MIL-C-45360E(AT)
AMENDMENT 5
1 May 1986
SUPERSEDING
AMENDMENT 4
20 December 1984

MILITARY SPECIFICATION

CARRIERS, PERSONNEL, FULL-TRACKED: ARMORED,
M113 AND M113A1; AND MORTARS, SELF-
PROPELLED: 107MM, M106, AND M106A1;
AND 81MM, M125A1; PROCESSING FOR
STORAGE AND SHIPMENT OF

FIGURE 4A. Screen.

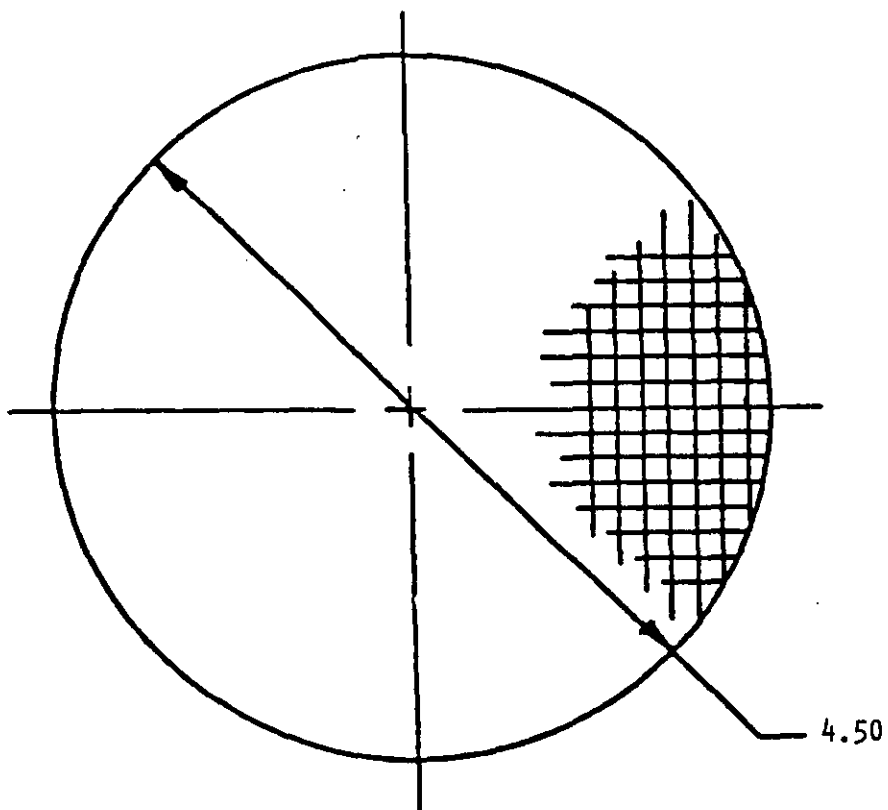
Add the following page "29-1" entitled "FIGURE 4A. Screen.", after page 29.

1. MATERIAL: WIRE CLOTH, TYPE I, CLASS I,
4 x 4 MESH, 0.0348 DIAMETER, SPEC RR-W-360.
2. DIMENSIONS ARE IN INCHES.

FIGURE 4B. Spring retainer.

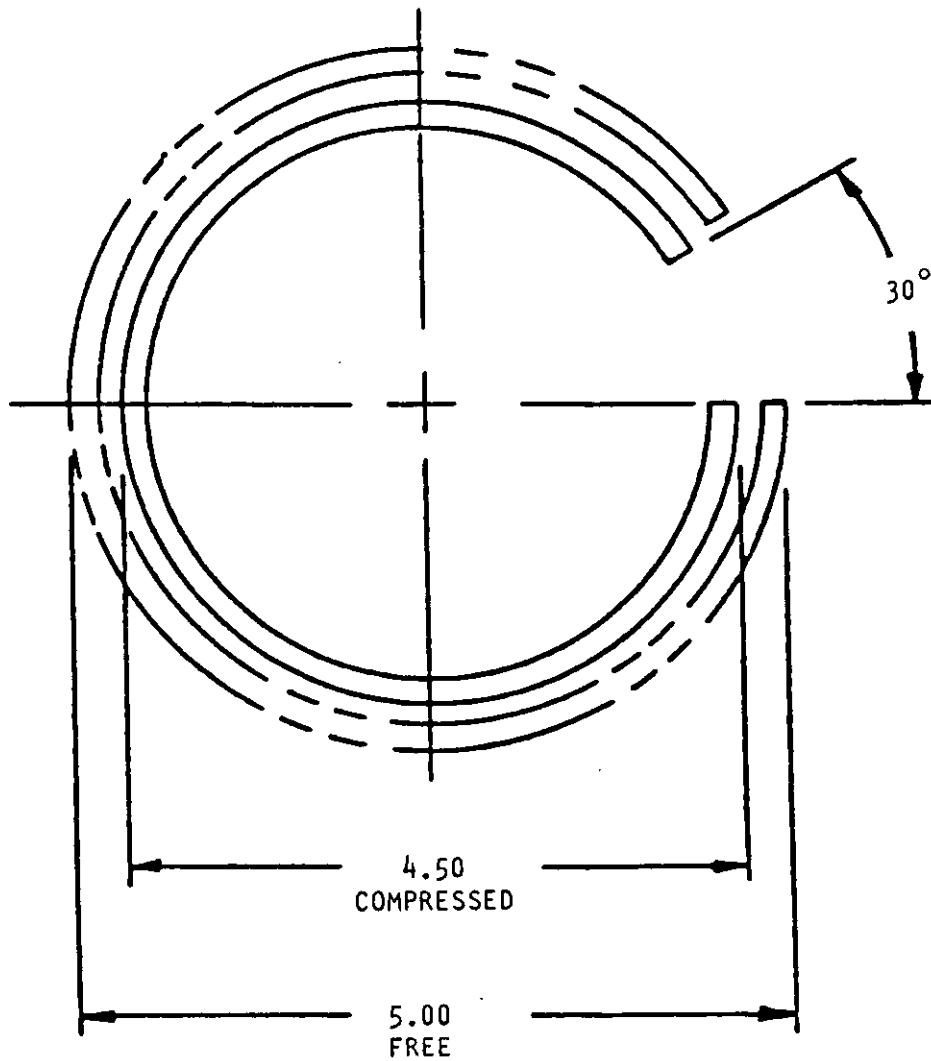
Add the following page "29-2", entitled "FIGURE 4B. Spring Retainer.", after page 29-1.

1. MATERIAL: WIRE, STEEL, MUSIC, 0.156 DIAMETER, SPEC QQ-W-470.
2. DIMENSIONS ARE IN INCHES.
